AGENDA

Planning Committee Meeting to be held
at Darebin Civic Centre,
350 High Street Preston
on Monday, 15 April 2019
at 6.00pm.

5.1 DEVELOPMENT PLAN POD/1/2007/E 1056-1140 AND 1142 PLENTY ROAD, BUNDOORA (POLARIS - FORMER LARUNDEL PSYCHIATRIC HOSPITAL)

Figure 60 Indicative Section Through Precinct 1B

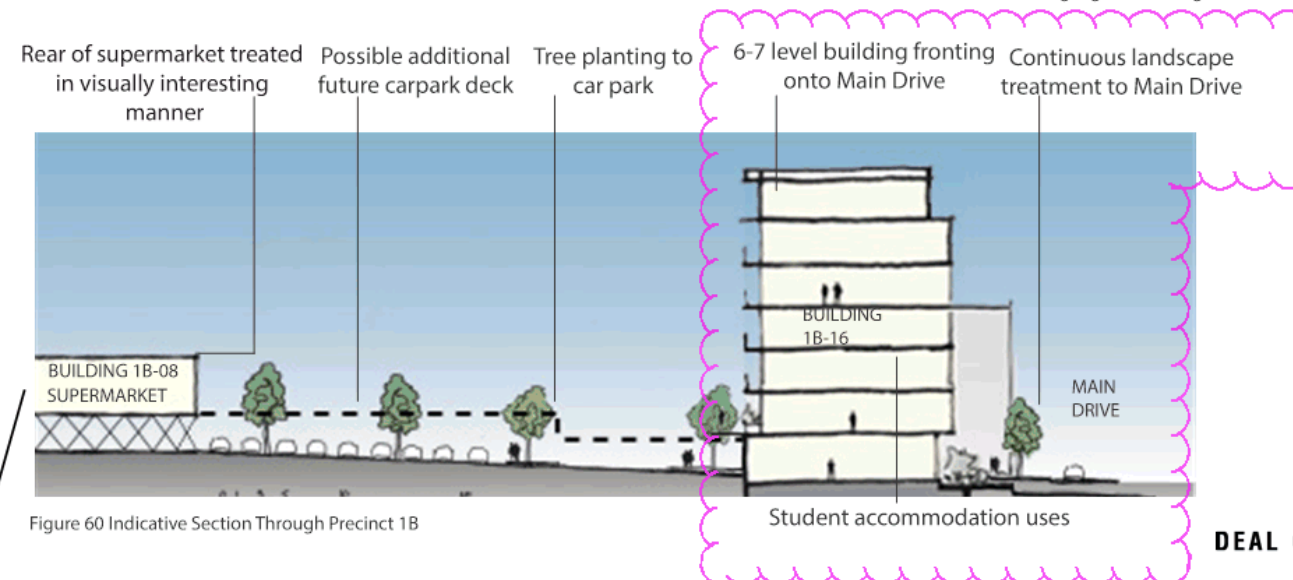
- d) Treatment of the Galileo Gateway South interface of Lot S9;
 - e) Inconsistencies between the text description and Figure 60 (both Page 44) regarding the use of Building 1B-16;

The text within the PDP continues to state that the building “*may possibly be used for either commercial or residential uses. However, the use of this building is not determined at this stage, and will be proposed at the planning permit stage of the development*”. Notwithstanding, the revised Figure 60 provided by the Applicant indicates that the building will comprise student accommodation uses.

For consistency, the text within the PDP should be updated to reflect the clear intention of Figure 60.

Figure 80 Landscape Concept Plan / Overall Master Plan (Indicative Only)

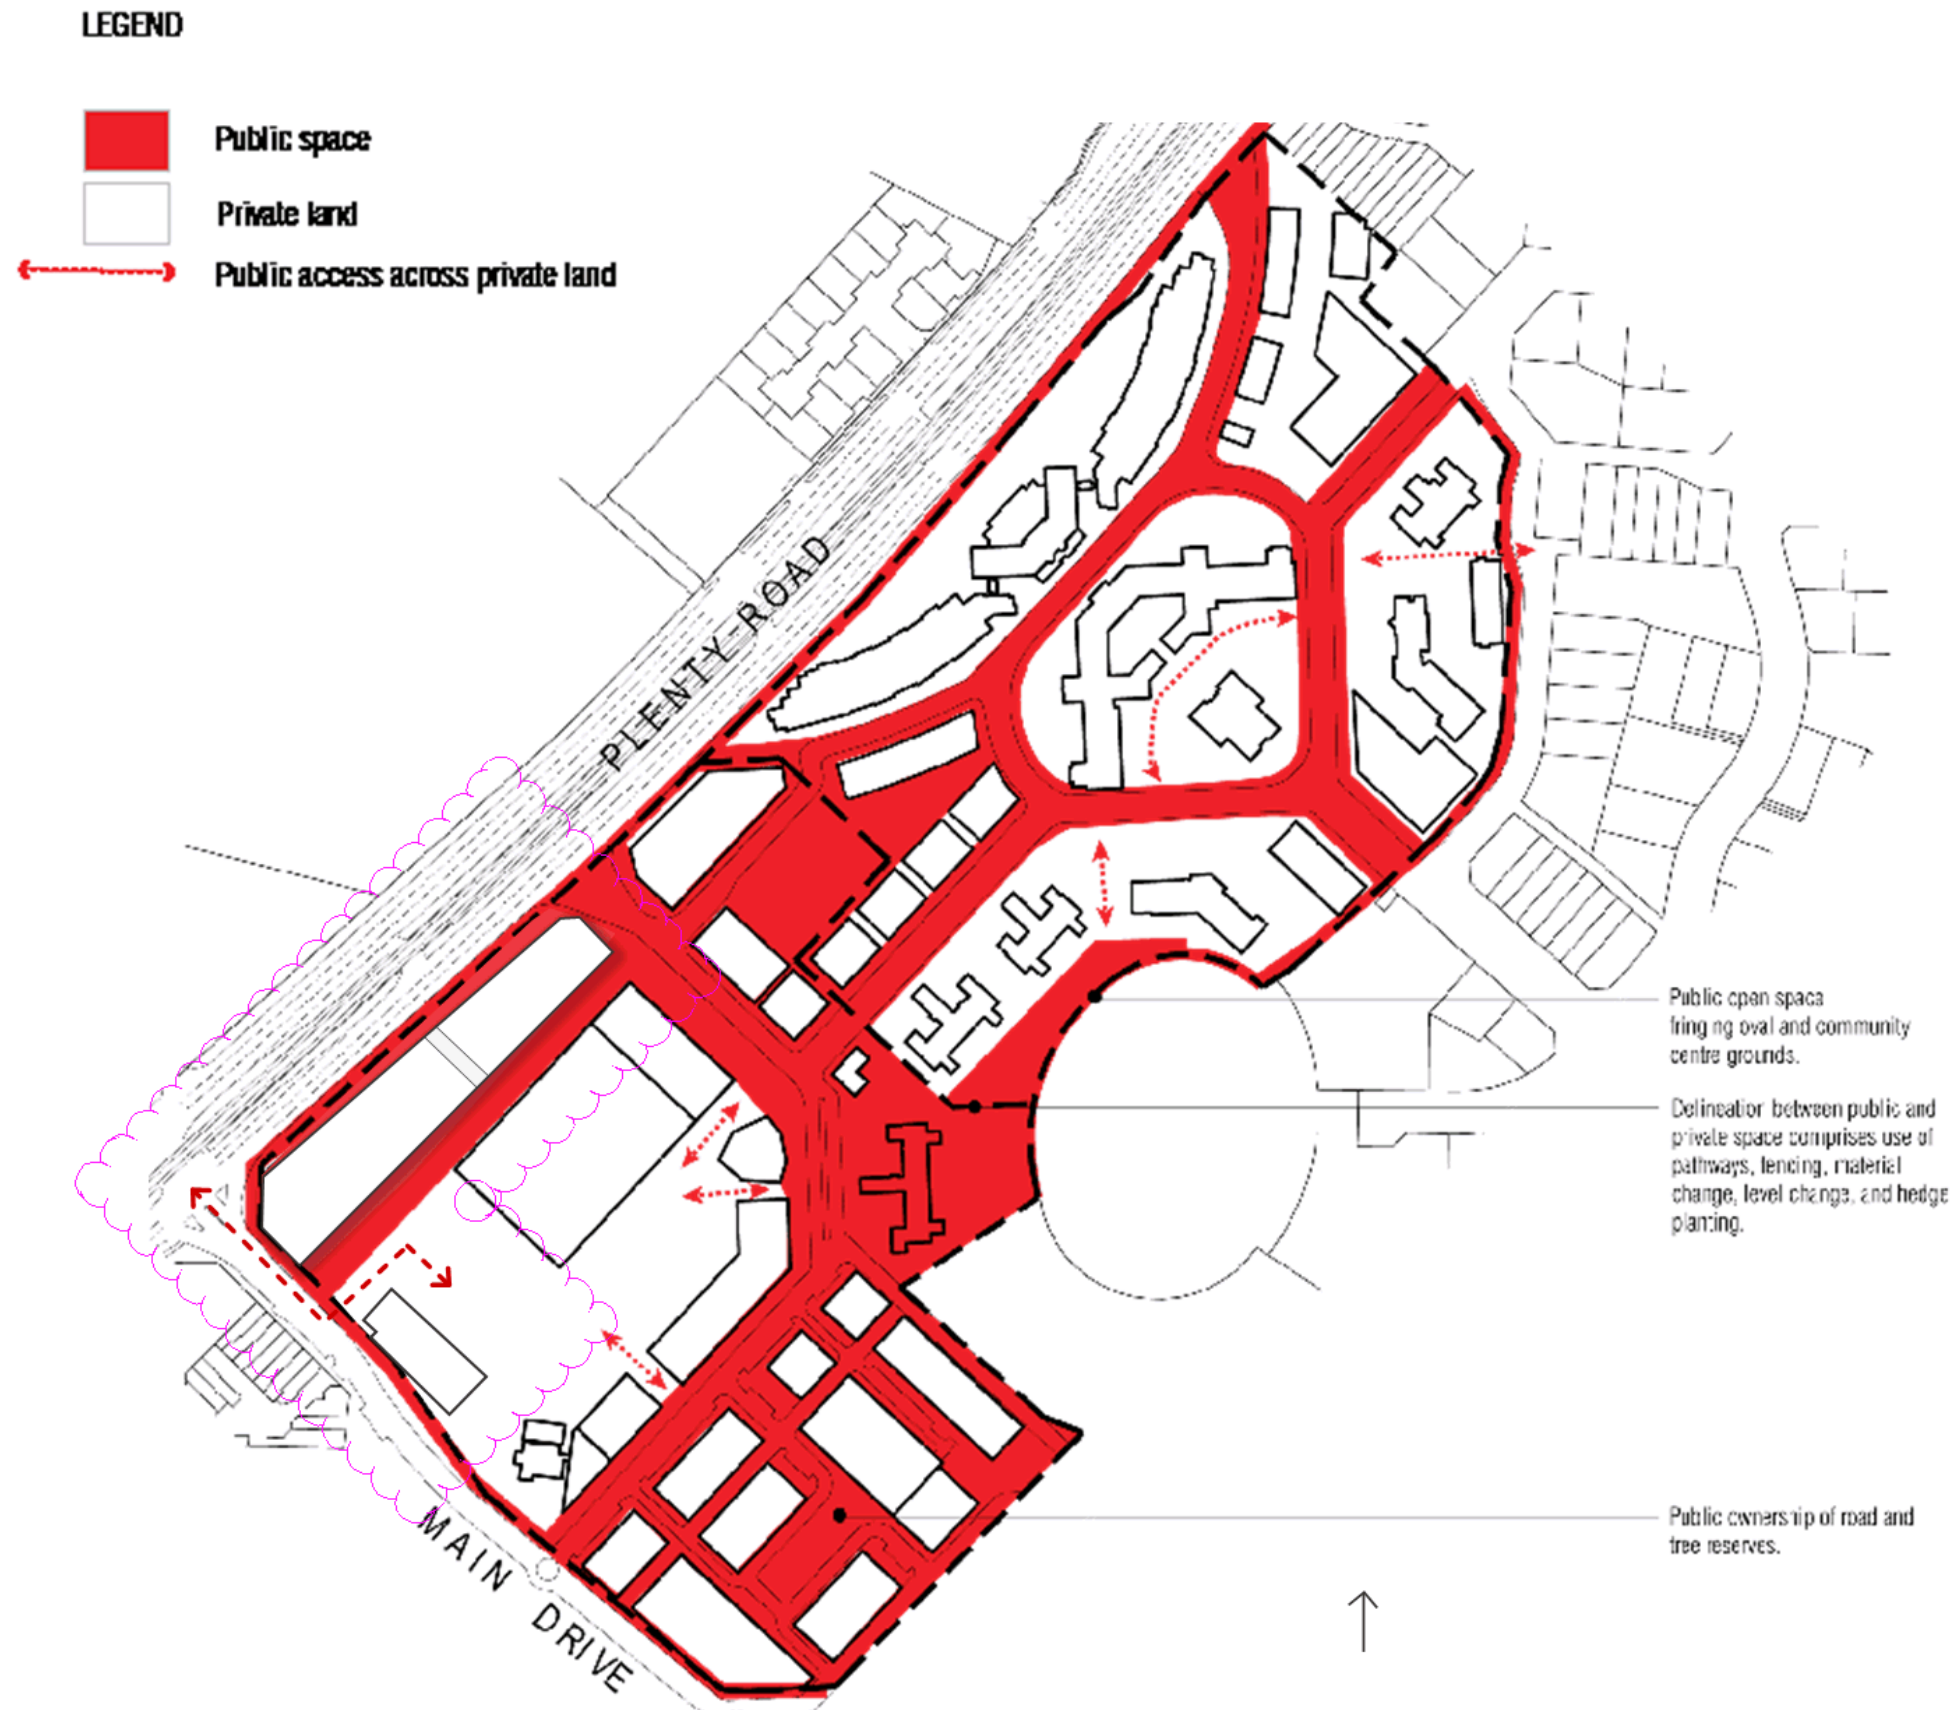
- f) Details of the pedestrian environment for the Galileo Gateway South/car park route and the covered pedestrian walkway nominated in Figure 80; and

While a 'covered pedestrian walkway' continues to be noted on the plans (see Figure 80), this appears to a legacy annotation from the proposed PDP originally lodged with Council for consideration.
